Mr. Jensen Uchida  
San Joaquin Cross Valley Loop Transmission Project  
c/o Environmental Science Associates  
225 Bush Street, Suite 1700  
San Francisco, CA 941004

**Re: A.08-05-039 - Comments on Draft Environmental Impact Report**

**Figure 1**

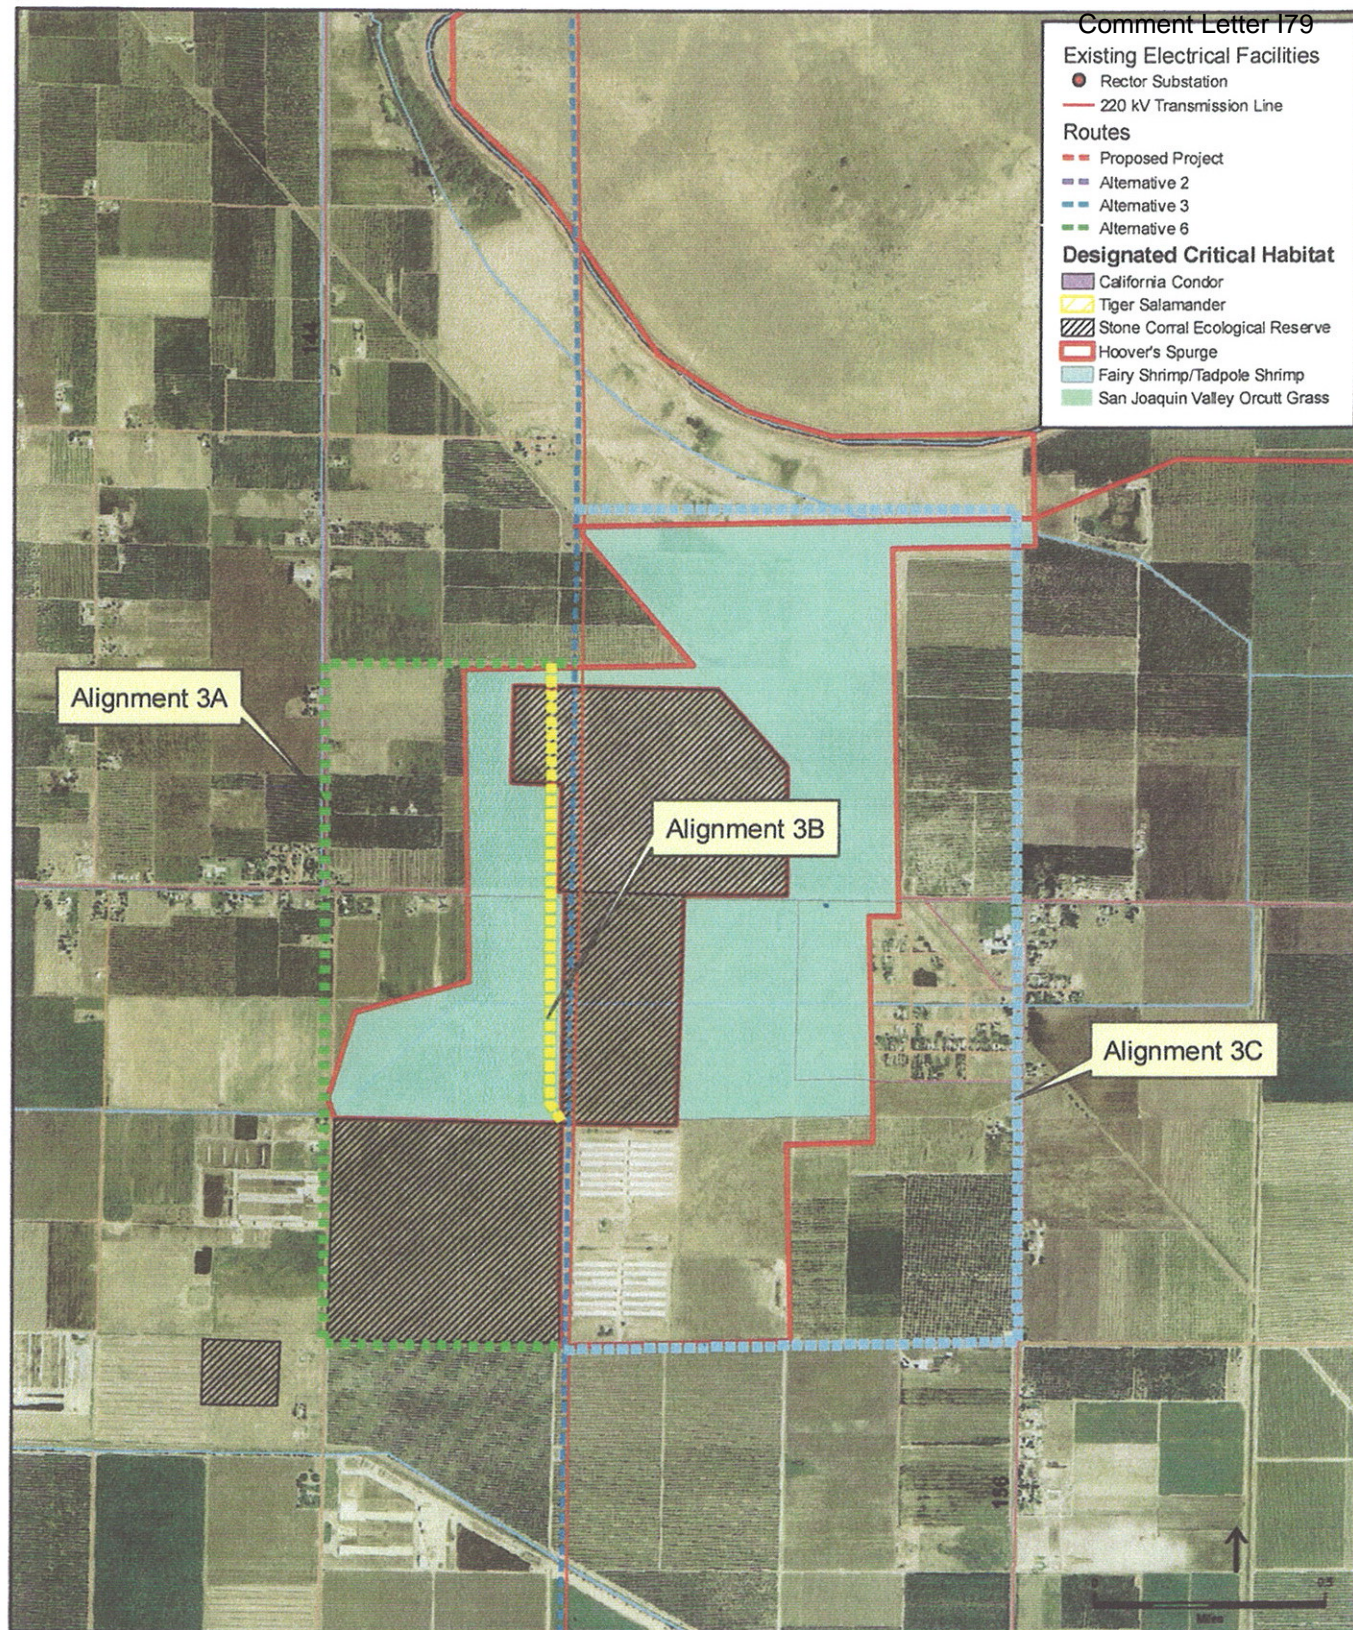
Q 1. What specific properties on both sides of the preserve displayed sufficient additional sensitive habitat to cause rerouting not feasible? Alignment 3A is pushed so far west that it clearly passes through the hamlet of Yettem. Alignment 3B fails by reason of transecting a portion of the Reserve that is said to also traverse federal designed (sic) critical habitat for Hoover's spurge and vernal pool fairy shrimp and vernal pool tadpole shrimp beyond the

northern limit of the Reserve. There is no indication that this alignment was surveyed for the primary constituent elements of habitat outside of the Reserve. The band identified as habitat is so narrow that it could be easily spanned without disturbing the underlying land. Alignment 3C was deemed the nearest available alternative, but fails to resolve location on previously disturbed lands and opportunities for spanning critical biological resources.

Q 2. What specific properties on both sides of the preserve contained building improvements of sufficient sizes and values to cause rerouting not feasible? Although this question was not answered in writing, the choice of Alignments 3A and 3C transect neighborhoods in the hamlets of Yettem and Seville, indicating there was no effort made to route around the residences.

The alignments 3A, 3B and 3C depicted in figure 1 of the memo, fail to demonstrate a good faith effort to avoid any of the potential biological and other constraints to location of a feasible routing alternative. In light of the importance and the consequences of this determination, **the response of the ESA biologist is woefully inadequate and misleading.** It falls short of the CEQA requirement that there be a good faith effort to inform decision makers and users of this EIR.

**Figure 4.1-11a and 4.1-11b**  
Visual Simulation of Project Site

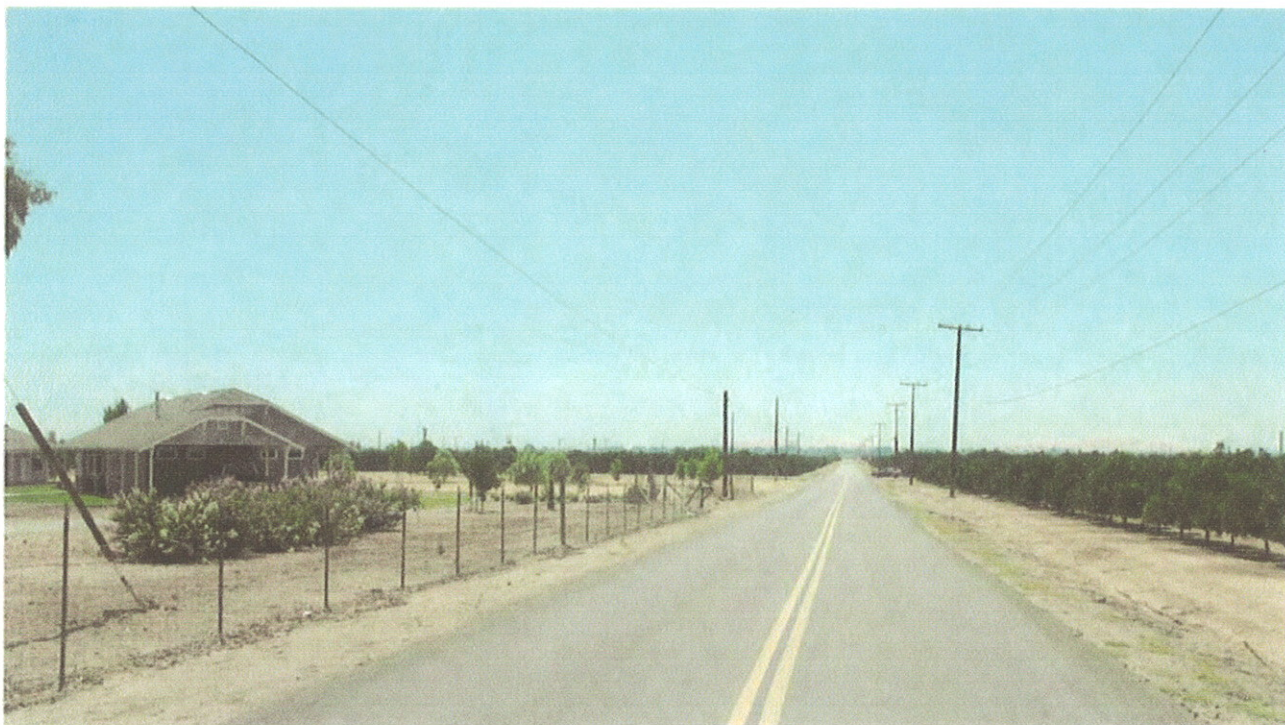
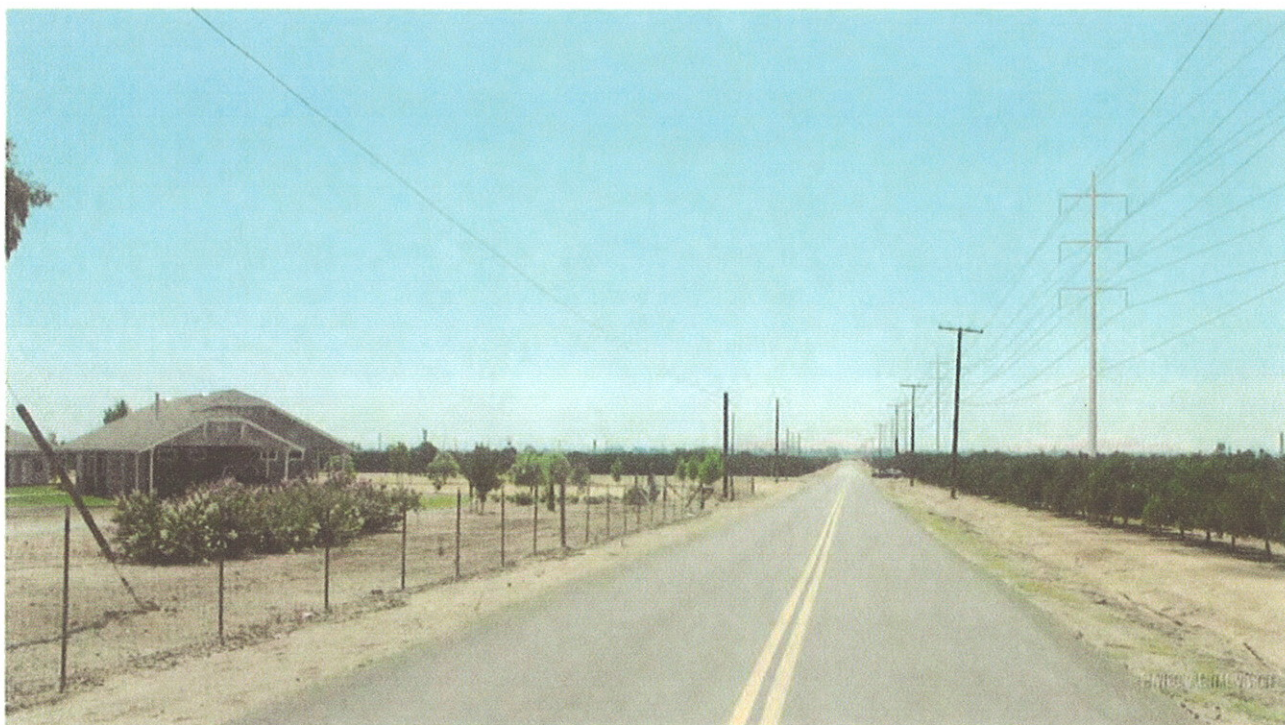
The DEIR is particularly disappointing because the author(s) failed to do their own work, relying instead on the Edison company's PEA for a number of misleading Visual Simulations - "before and after" graphics of how the lines will impact the unique regional character this pristine rural area. Granted, ESA took a few pictures, but the one we're intimately familiar with is from SCE and it is completely misleading, if not simply fraudulent.

We refer specifically to Figures 4.1-11a and 4.1-11b. This is an Alternative 1 illustration that shows lines and poles along Cottage Post Office Road (Ave. 320) looking west near our neighbor's house. Instead of using a side-by-side comparison, SCE chose to simulate Pole #82, which is some distance from the house. From that angle and that perspective, of course it does not appear as large and visually intrusive as it should. Nevertheless, we did the same.

Curious about just how high a 120'-160' pole might be, we tethered a helium-filled balloon on a 150 foot line from the exact location of the proposed pole identified as Structure 82 in the Road Story illustrations. It's humongous! "Attachment B" Includes a picture we took of the balloon and several corrected versions of Figure 4.1-11b.

150' balloon tethered  
at structure #82 on  
Cottage Post Office road  
- Ave 320

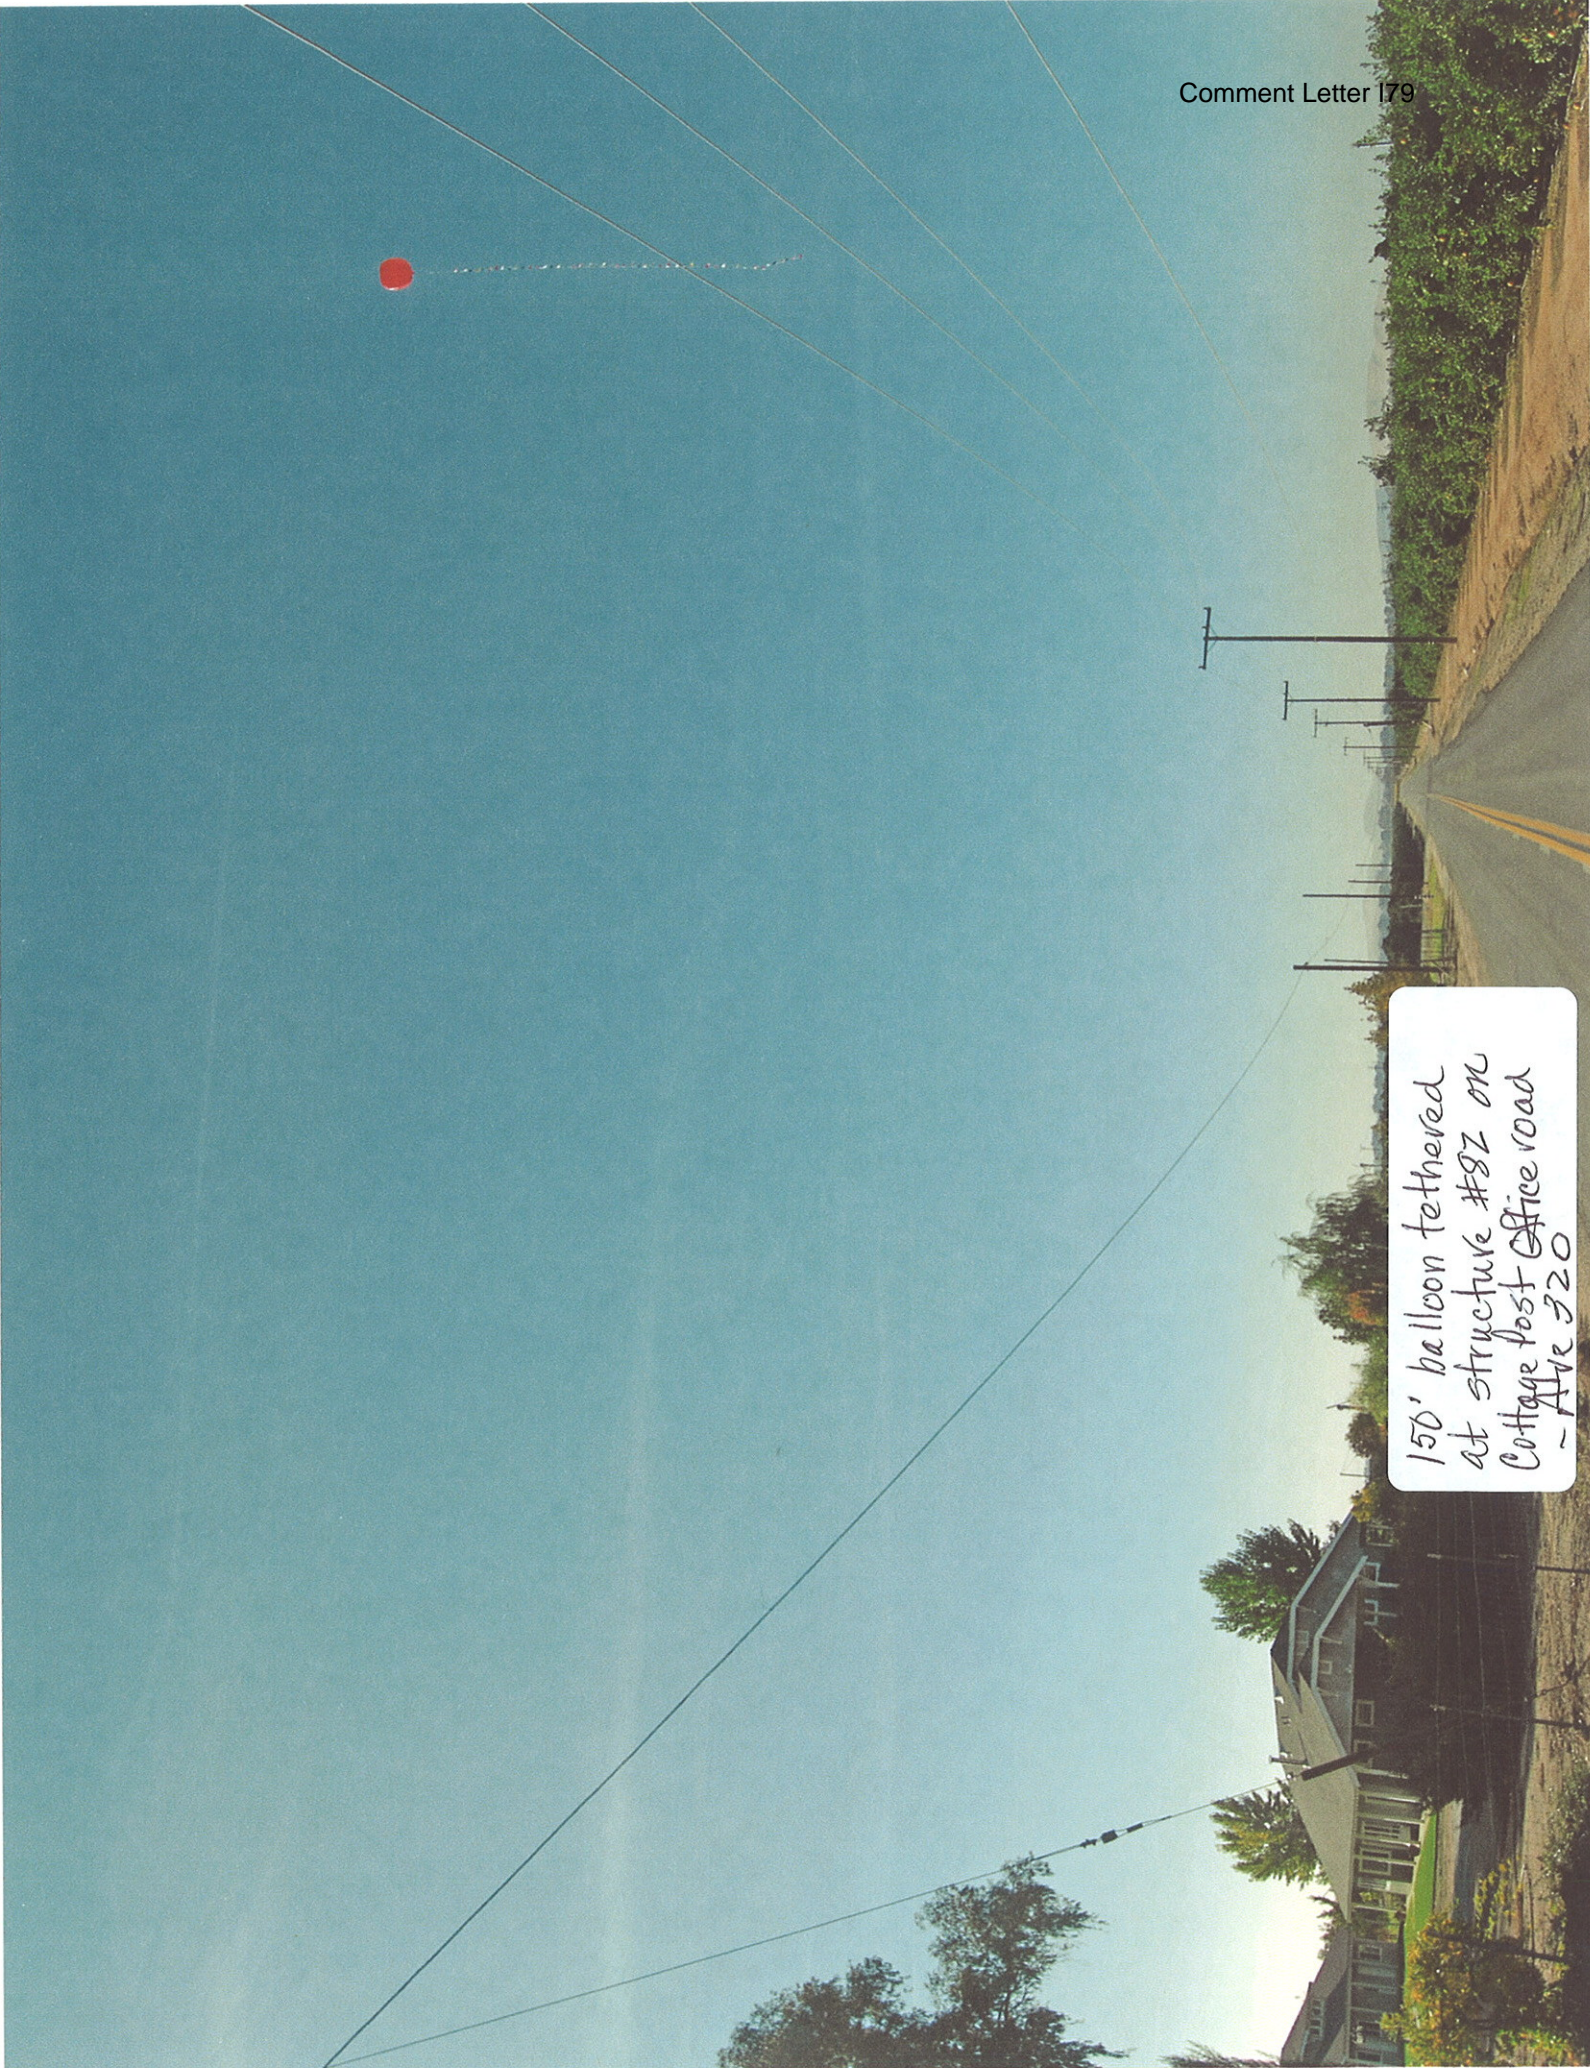
Taking the process a step further, we decided to apply it to our own viewshed – using both the tethered balloon and a friend flying his helicopter at the 150' elevation while we took pictures from our deck. The panoramic view with poles added is included.

Perhaps we need to remind you the existing wooden utility distribution poles on Cottage PO Road are 35 feet high. Wind machines are 35-feet high. The new poles and towers are 120'-160' high. This is NOT an incremental change, as SCE would like you and everyone else to believe. Incremental, is in my dictionary. Incremental is defined as a small, or slight change ... by degrees. Four times the height of existing infrastructure is not incremental!
